SSDA Mods

1.1 Facade Materiality

Modification 1 to SSDA

Proposed East Elevation [SMCSWSPS-FOS-OSN-AT-DWG-960003 Rev E]

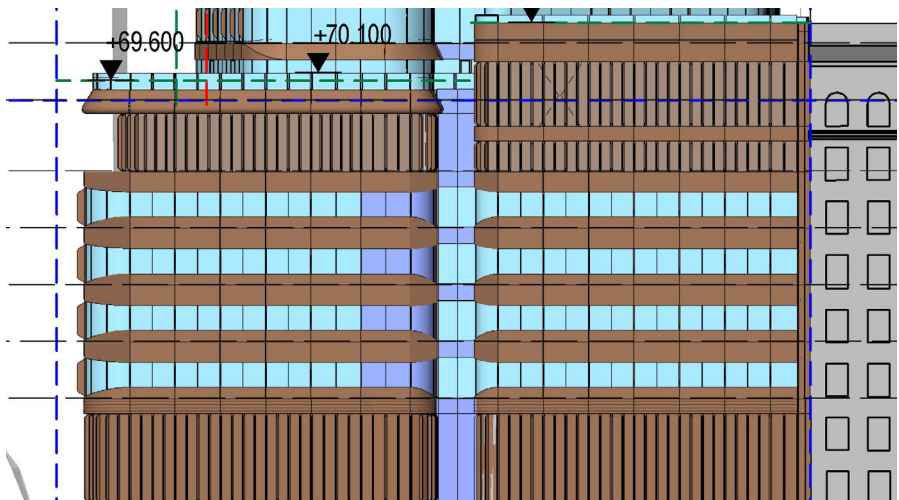
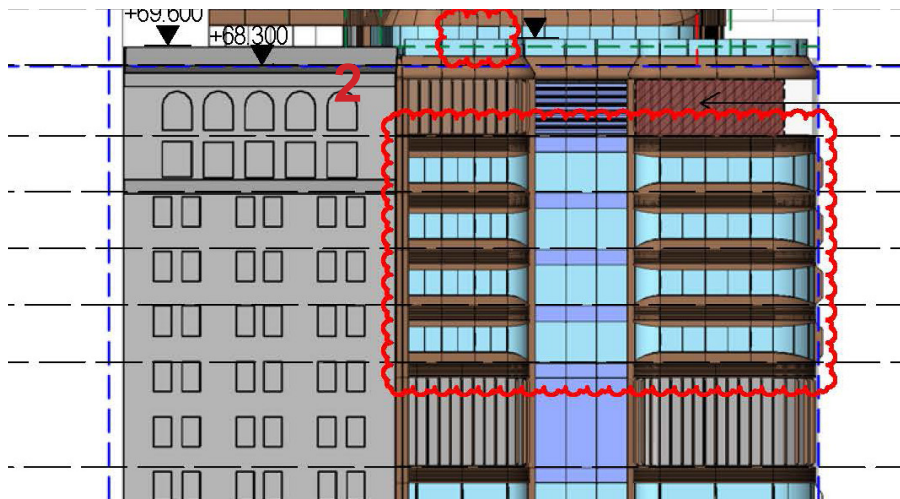
A correction has been made to the podium facade (level 5 through to level 9) on the eastern and western elevations to accurately show the corrugation detailing. This change is a graphical fix as illustrated.

- 1. Correction to Eastern Podium Façades.
- 2. Correction to Western Podium Façade.

Proposed: South Elevation [SMCSWSPS-FOS-OSN-AT-DWG-960002 Rev E]

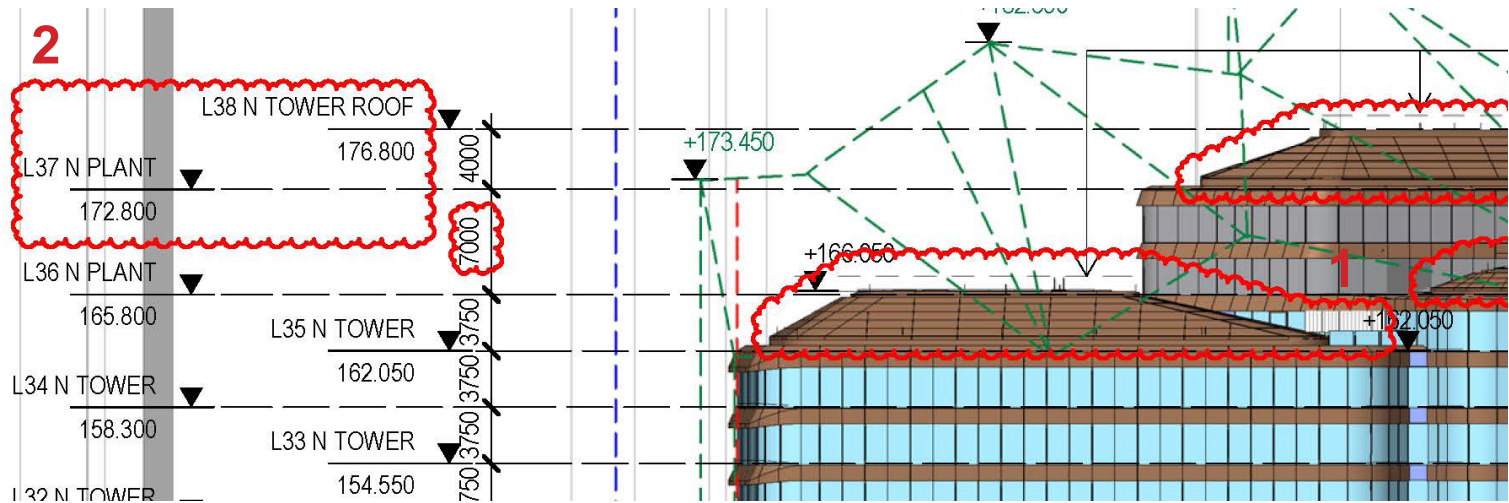
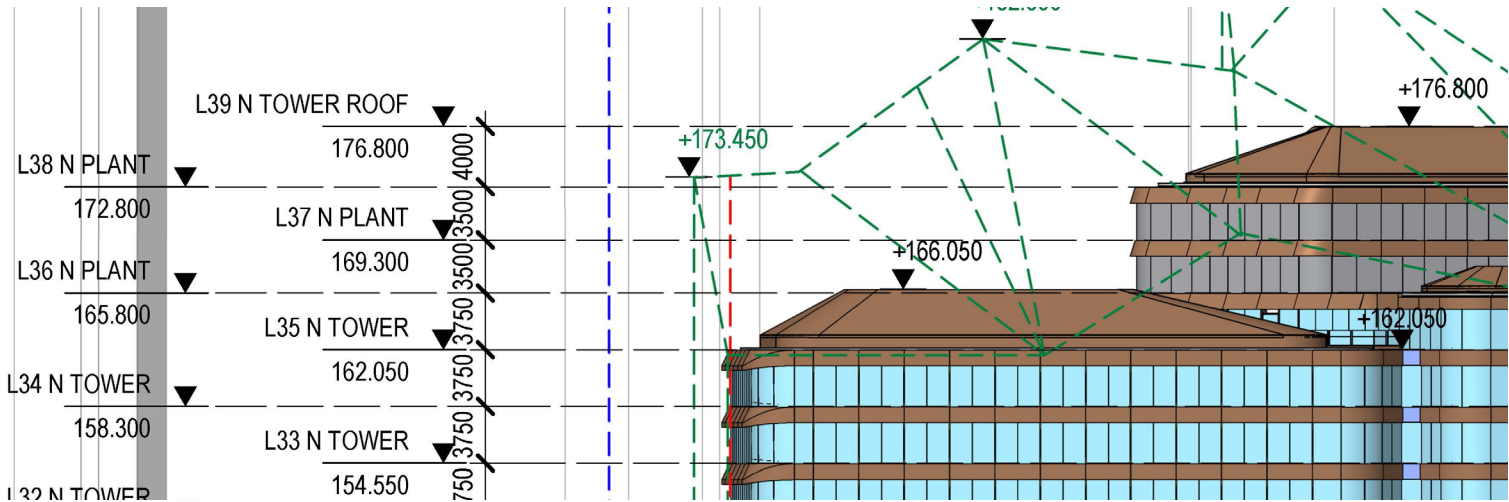
1. A correction has been made to the south western roof facade (level 35) show the fluted glazing for the toilet amenities. This change is a graphical fix as illustrated.

Proposed: Section B-B [SMCSWSPS-COX-OSN-AT-DWG-950010 Rev E]

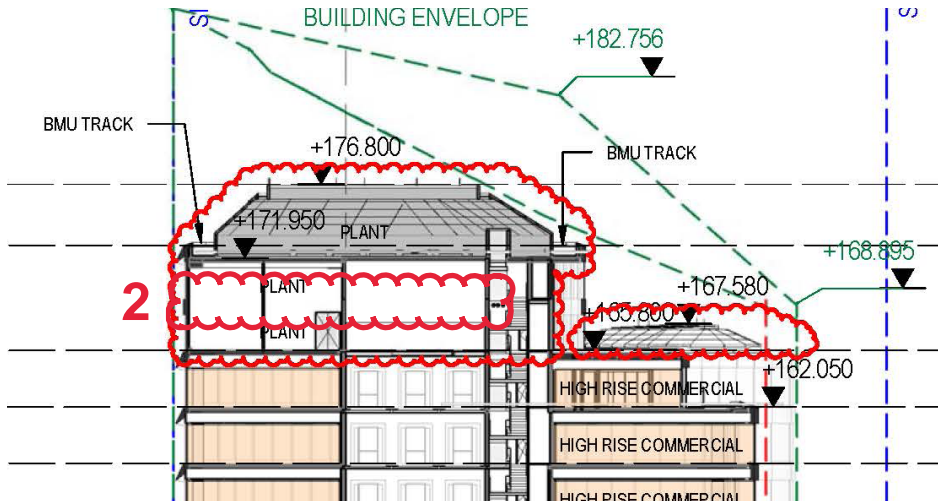
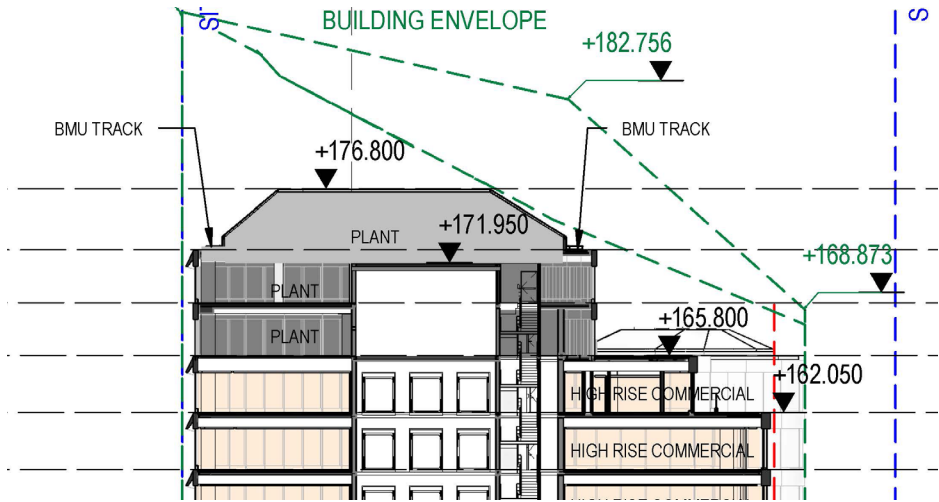
2. Roof Project Levels have been updated.

Previous Level 37 has been removed as there are no plant rooms on this level. The slab shown on this level is not needed and is now a void, however the height has been maintained.

Previous level 38 is now named level 37. Previous level 39 is now named level 38. This in no way effects the form of the roof.

Proposed West Elevation [SMCSWSPS-FOS-OSN-AT-DWG-960001 Rev E]

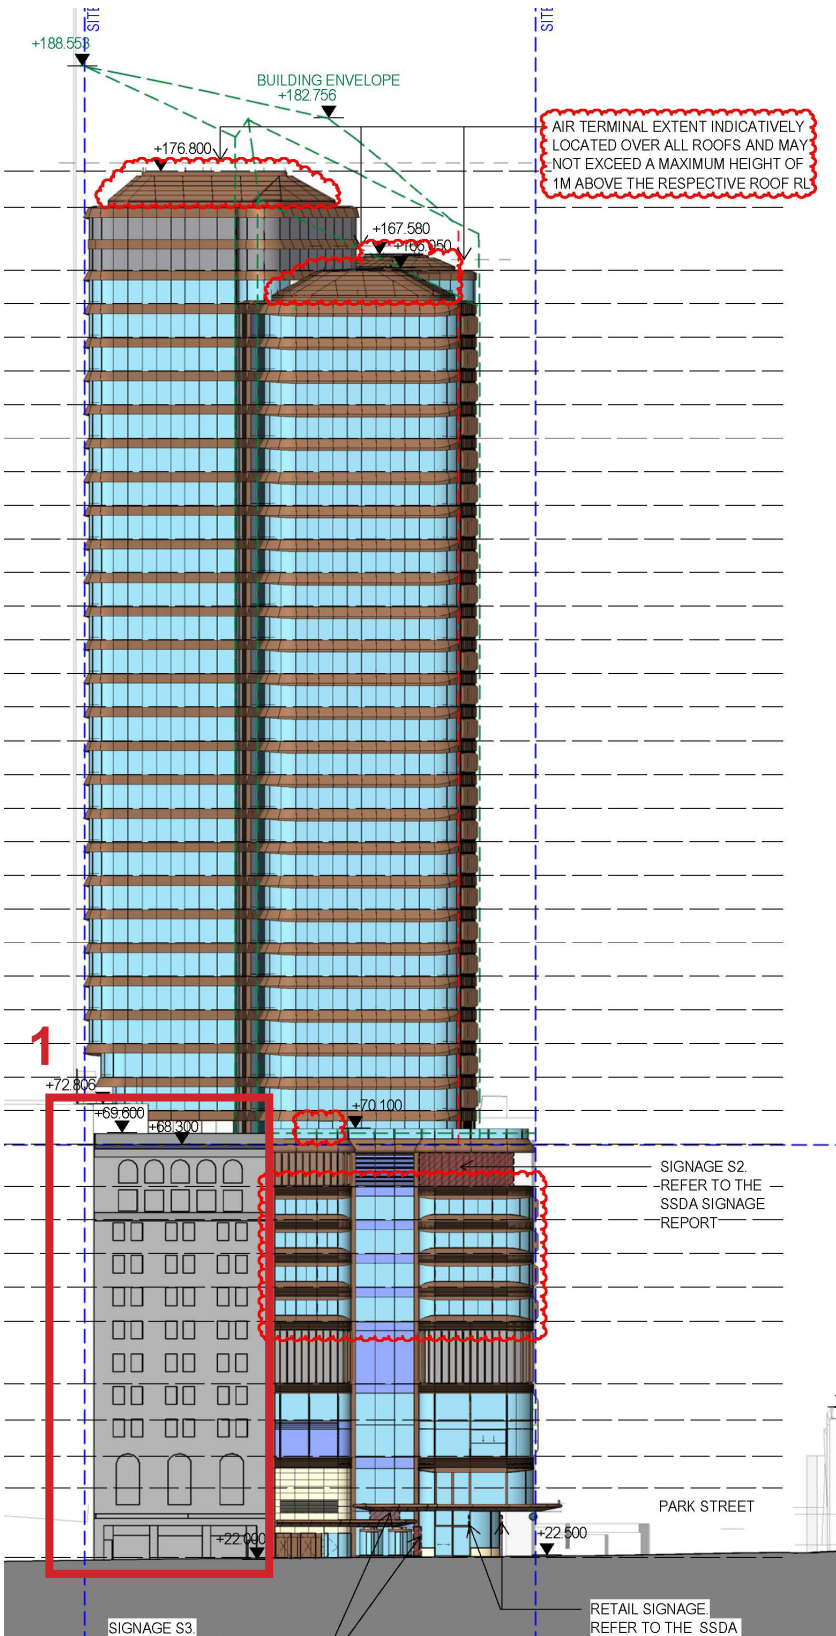
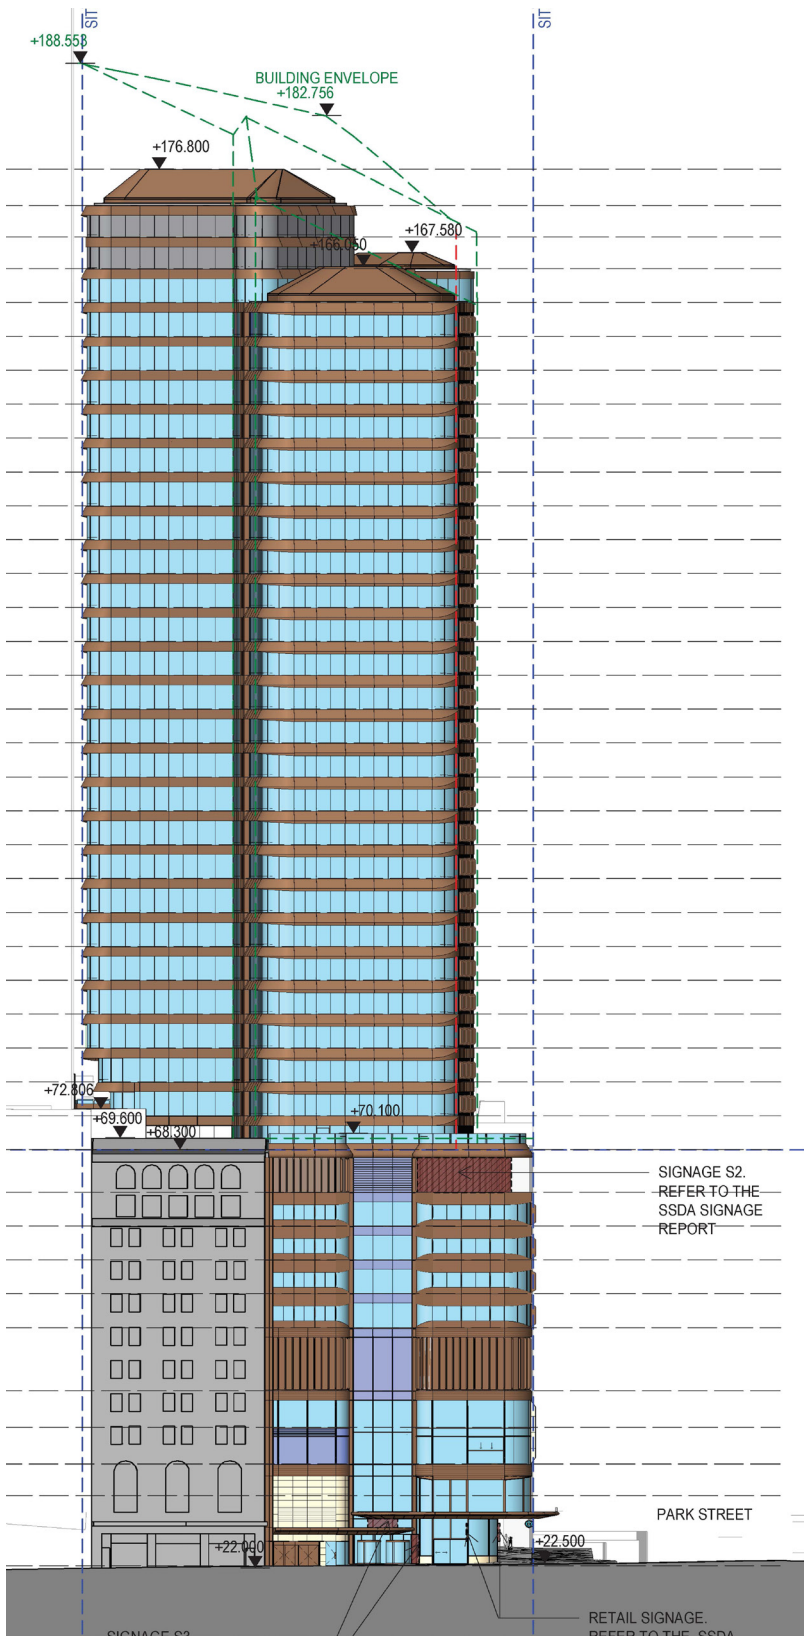
The north western façade of the OSD podium was not included in the approved General Arrangement Elevation West Elevation - Pitt Street Plan (drawing SMCSWSPS-FOS-OSN-AT-DWG-960001) as illustrated.

1. Approved General Arrangement Elevation West Elevation – Pitt Street (with missing north- south façade identified in red)

Proposed Modification: West Elevation - Ashington Place Lightwell
[SMCSWSPS-FOS-OSN-AT-DWG-960005 Rev A]

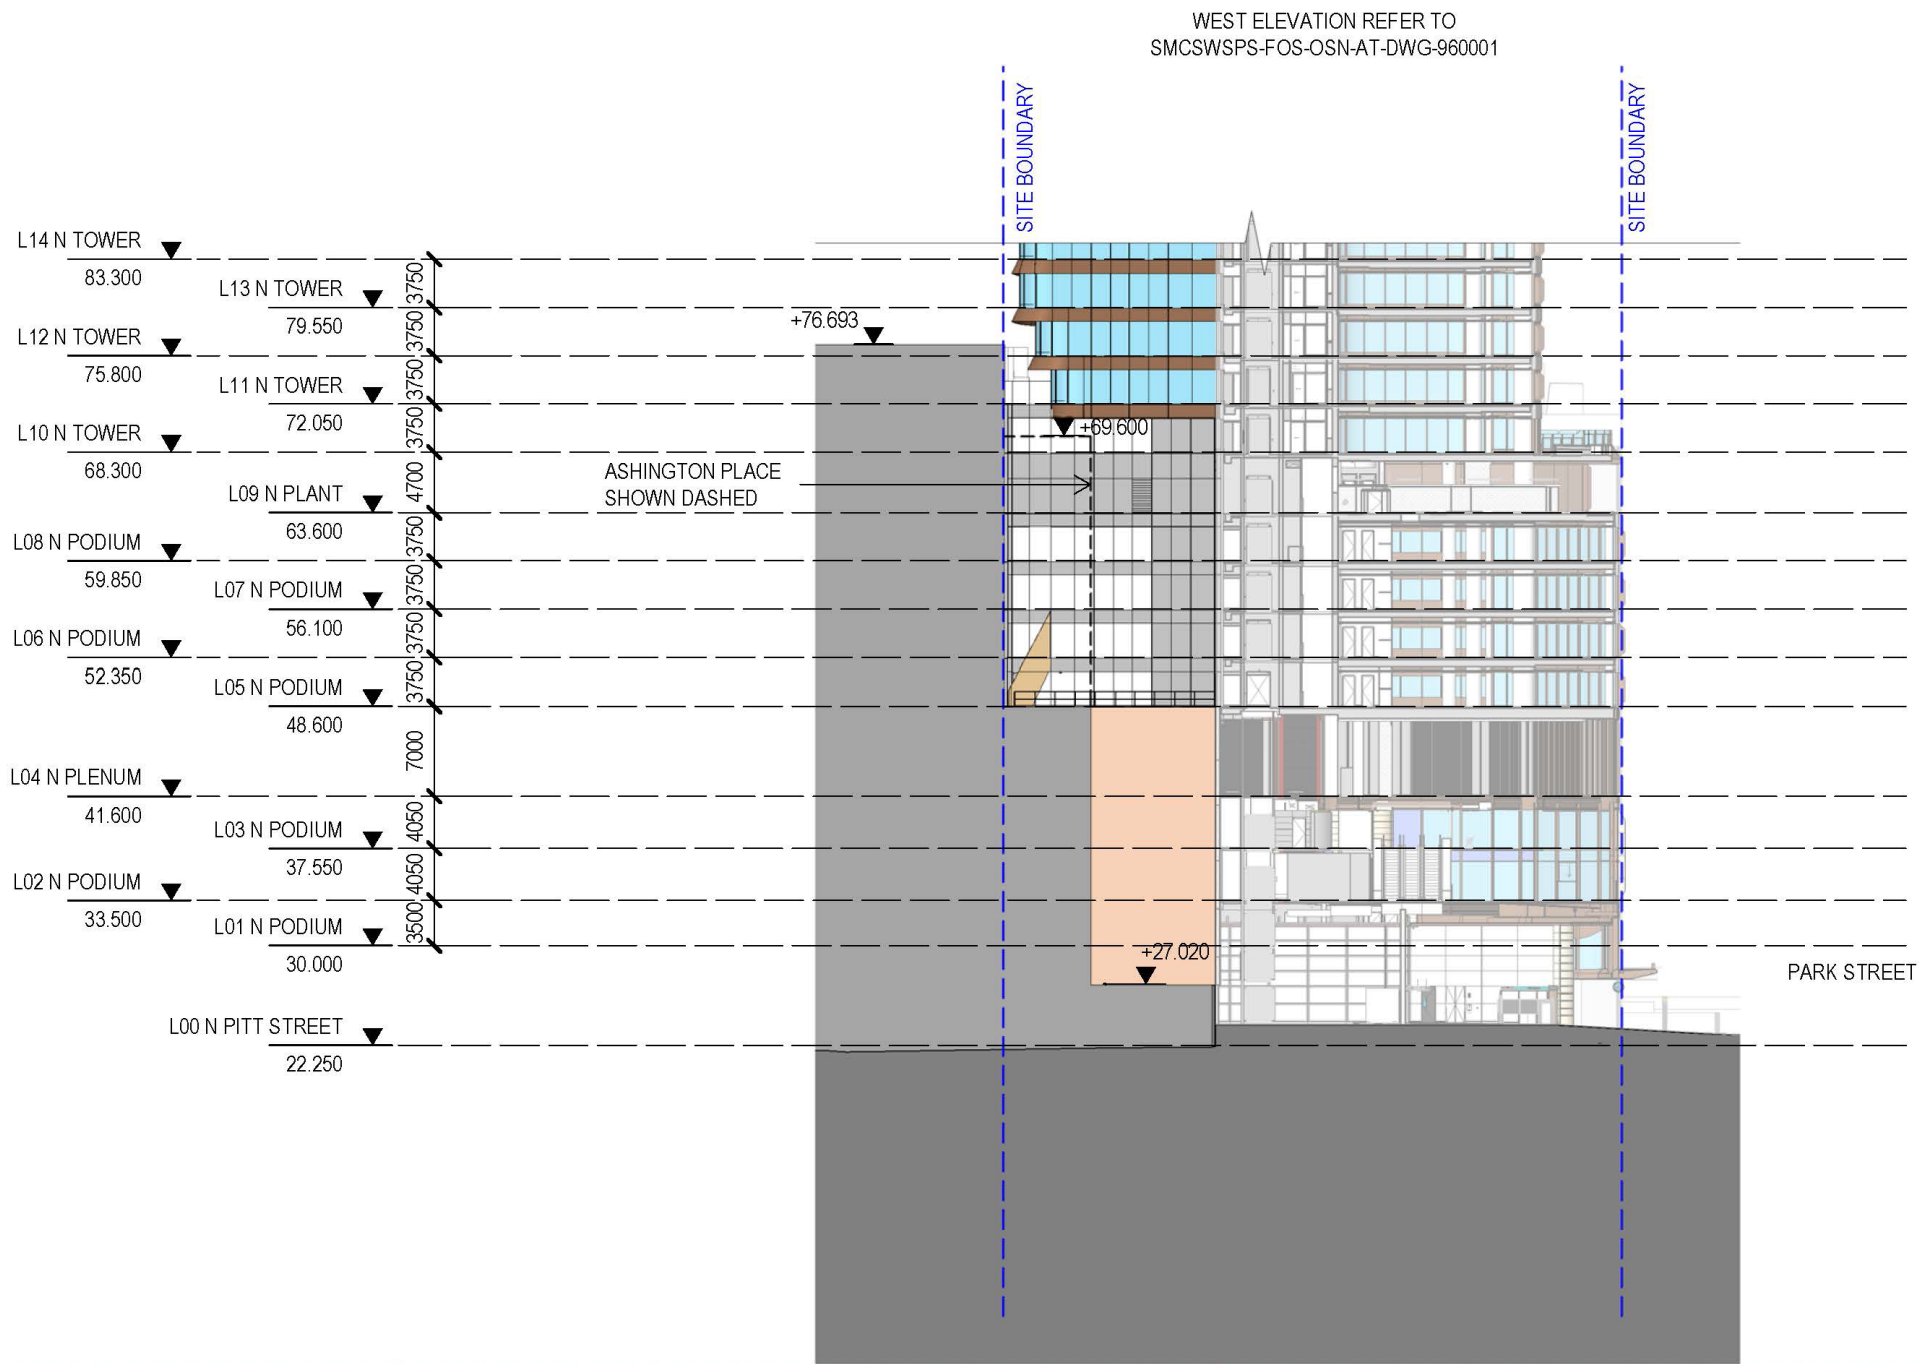
It is proposed to include an additional plan West Elevation - Ashington Place Lightwell (SMCSWSPS-FOS-OSN-AT-DWG-960005).

The proposed elevation cladding is consistent with the intent of the cladding shown on the north elevation lightwells. The adoption of translucent glass where office facades are located is an enhancement to the privacy of the development occupants and the neighbouring occupants.

L10 / L11 Autodoors

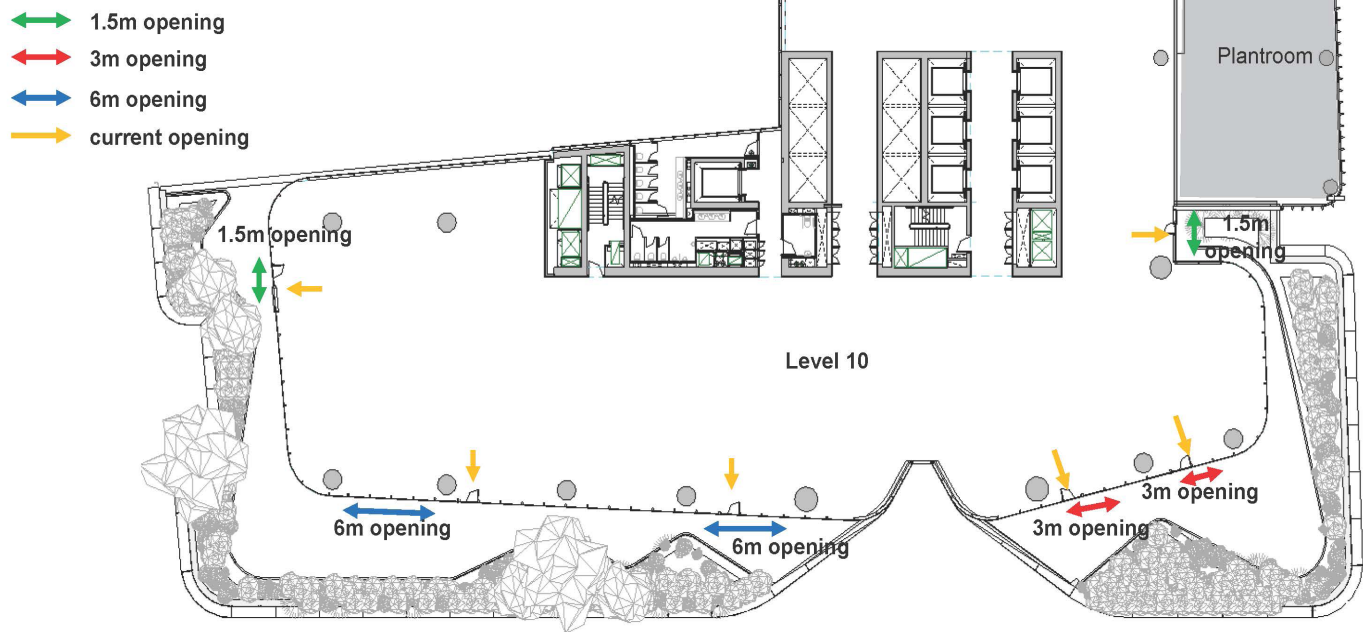
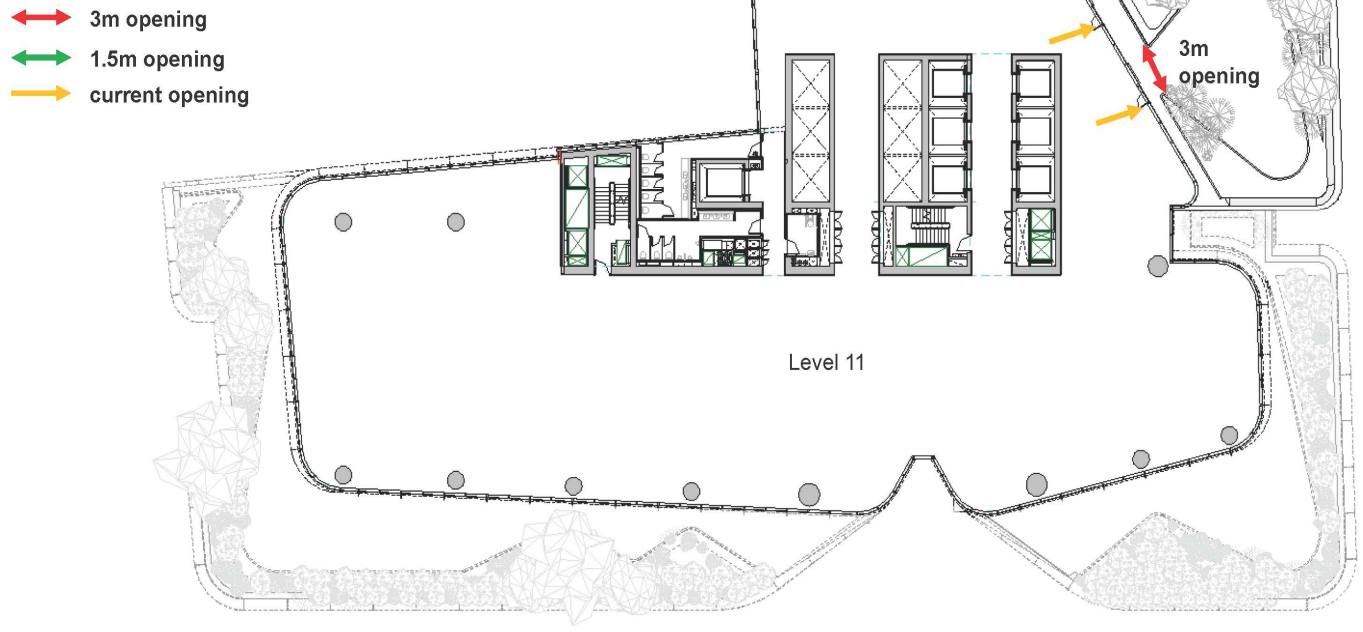
Terrace doors on Level 10 and 11 have been modified from single width swing doors to sliding doors to improve amenity of the tower, usability and access of the terrace areas.
